**DUKE POWER COMPANY**

Subject: Catawba Nuclear Station, Units 1 and 2  
Docket Nos. 50-413 and 50-414  
Inservice Inspection Program

Questions/Response from Telecon

Request for Relief from  
Inservice Inspection Requirement

FIG. IWB-2500-13 INTEGRAL ATTACHMENT WELD

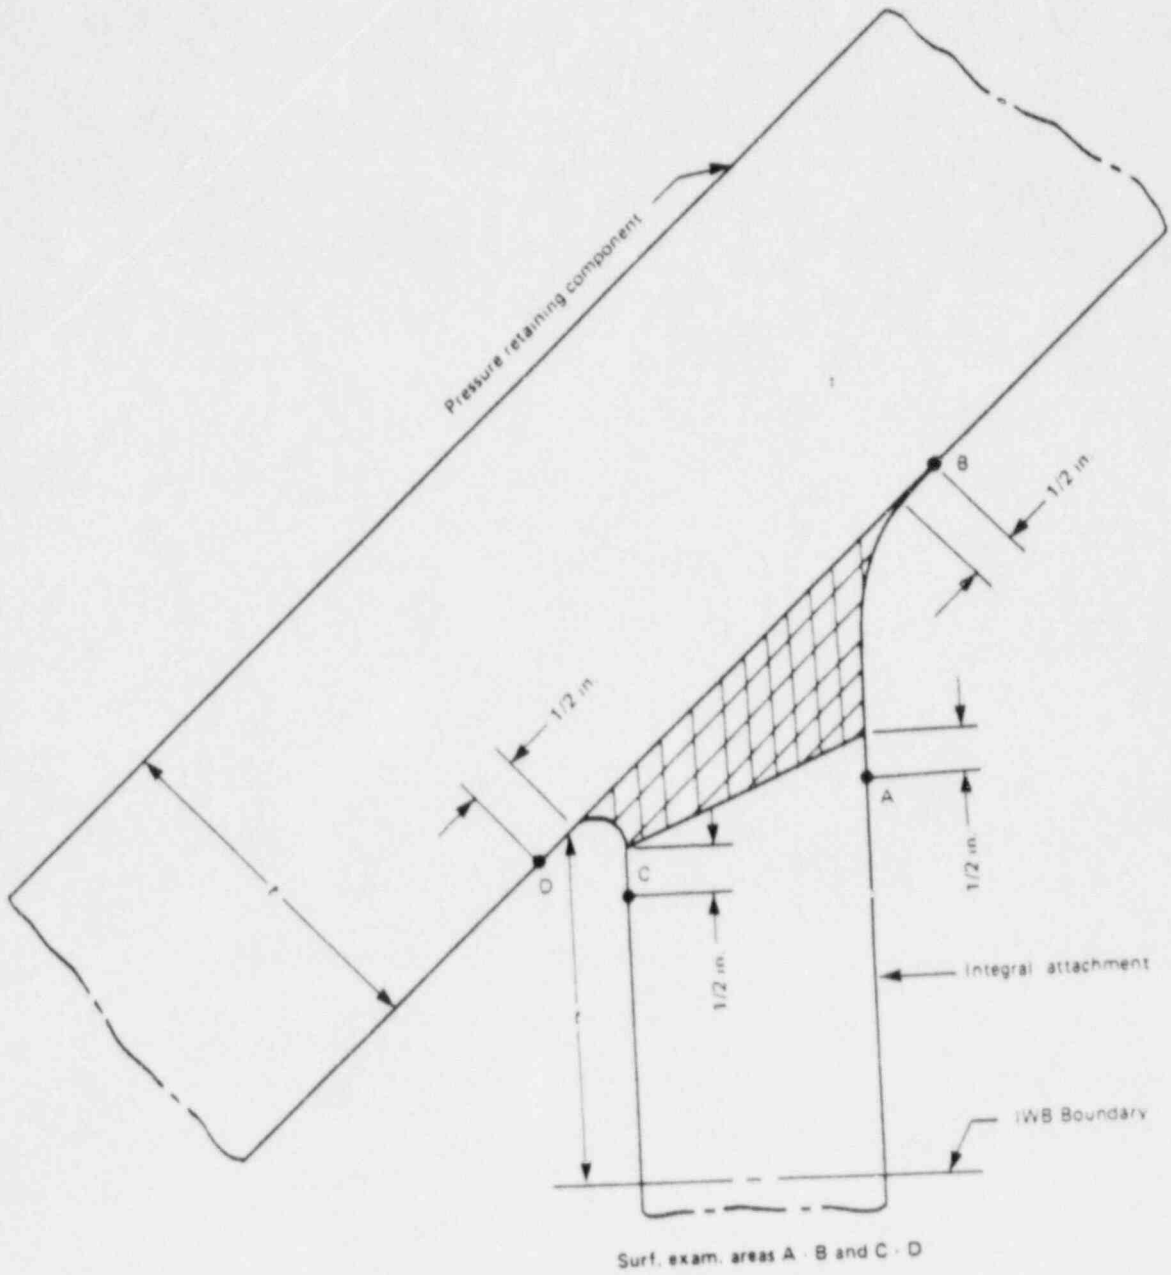
Section XI Table IWB-2500 Examination Category B-H, requires that 100% of the length of the integral attachment to vessel weld be included in the examination. The surface exam areas are shown in Figure IWB-2500-13. (Attachment IWB-2500-13 is included).

Relief requested from surface examination required on surface area C-D as shown in Figure IWB-2500-13. Surface area C-D is inaccessible for examination.

The weld will be examined from surface area A-B (OD surface) by magnetic particle testing.
